INALWAYS CORPORATION

Subject: European Safety Update

Inalways have taken the decision to change the European certification of the below listed series from ENEC to TUV approval.

0717-CQ-2BK (半成品) 设计变更外观对比

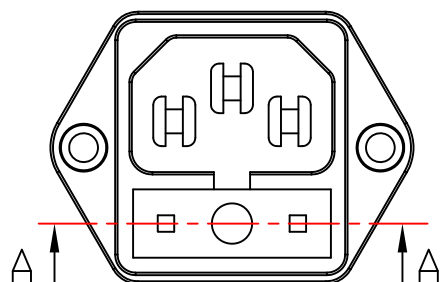
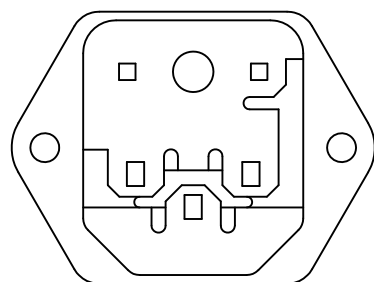
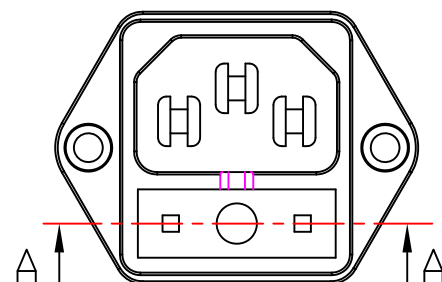
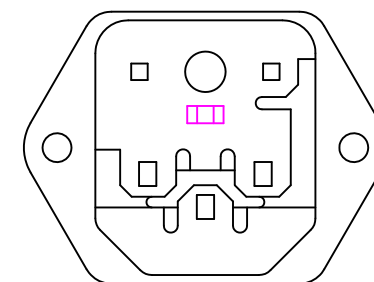
In order to meet compliance with the latest IEC regulations, reinforcement has been made to the fuse holder structure on 0717 series, this change to the structure does not have any impact on appearance, dimension and application of production. Structural changes can be viewed in the below attached drawings.
